## DOCUMENT CHANGE REQUEST

DCR number            382            Changes required for: General  
Date: 2007/10/16            Date sent: 2007/10/16  
Status: IMPLEMENTED

Title: Transistors Low Power NPN, based on types 2N3498 thru 2N3501

Number: 5201/013            Issue: 1

1.6 PHYSICAL DIMENSIONS AND TERMINAL IDENTIFICATION

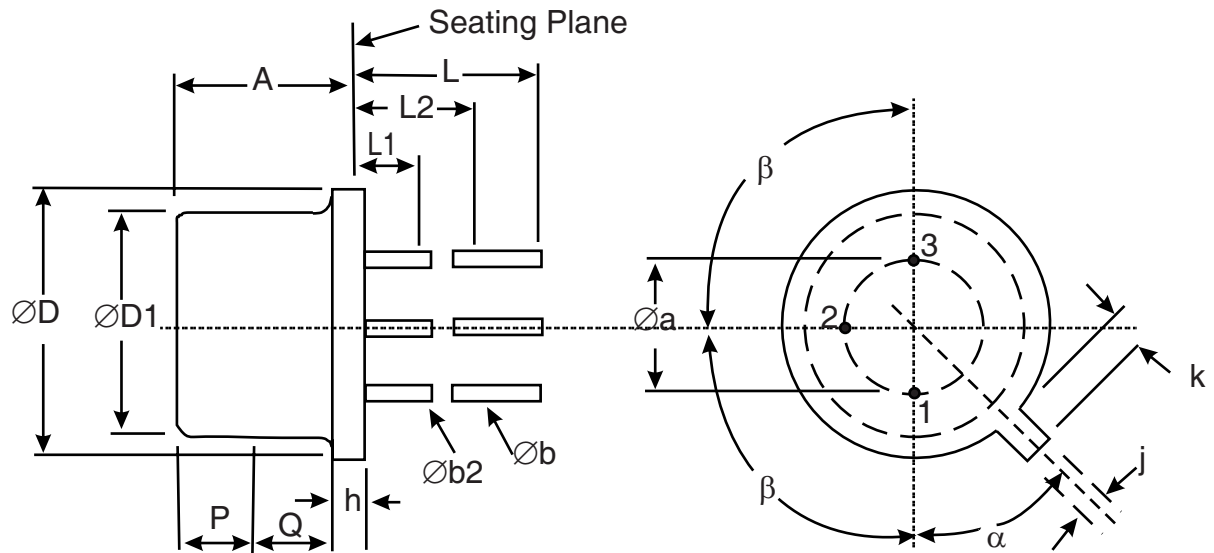
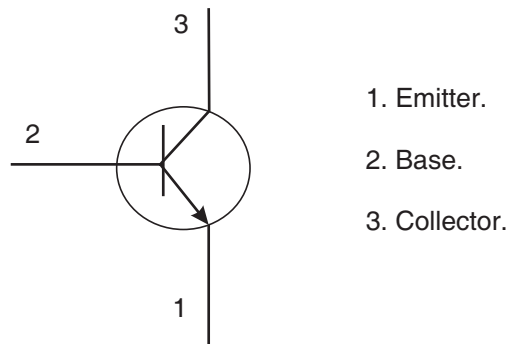
7. Para. 4.3.2 Weight requirements moved to Component Type Variants table.
8. Figure 2 re-named "Physical Dimensions and Terminal Identification"; Figures 2(a) and 2(b) amended (standardisation of the TO-5 and TO-39 packages).

VOLTAGE WAVEFORMS

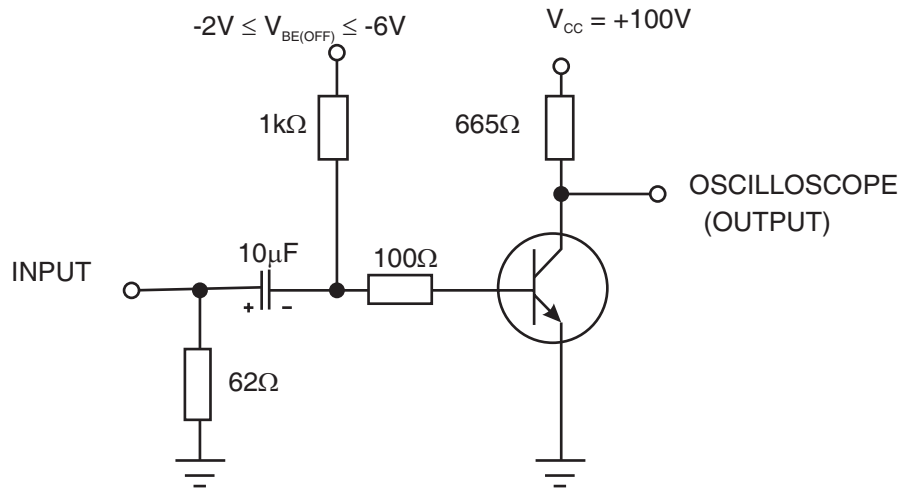
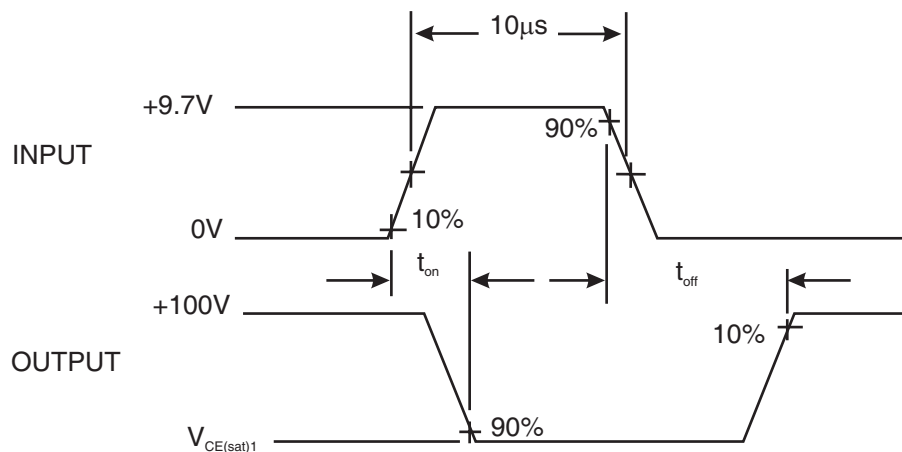
22. Figure 4 amended (and Voltage Waveforms added) and moved to be a note (Note 3) to Room Temperature Electrical Measurements.
23. Table 3, Characteristic "Collector-Base Cut-off Current": tolerance added to test temperature.

1. Pulsed measurement: Pulse Width  $\leq 300\mu s$ , Duty Cycle  $\leq 2\%$ .
2. For AC characteristics read and record measurements shall be performed on a sample of 32 components with 0 failures allowed. Alternatively a 100% inspection may be performed.
3.  $t_{on}$  and  $t_{off}$  shall be measured using the following test circuit. The input waveforms for  $t_{on}$  and  $t_{off}$  shall be supplied by a pulse generator with the following characteristics:  $Z_{OUT}=50\Omega$ ,  $t_r = t_f \leq 20ns$ , Pulse Width  $\geq 10\mu s$ , Duty Cycle  $\leq 2\%$ . The output waveforms shall be monitored on an oscilloscope

with the following characteristics:  $t_r \leq 1\text{ns}$ ,  $Z_{IN} = 50\Omega$ .
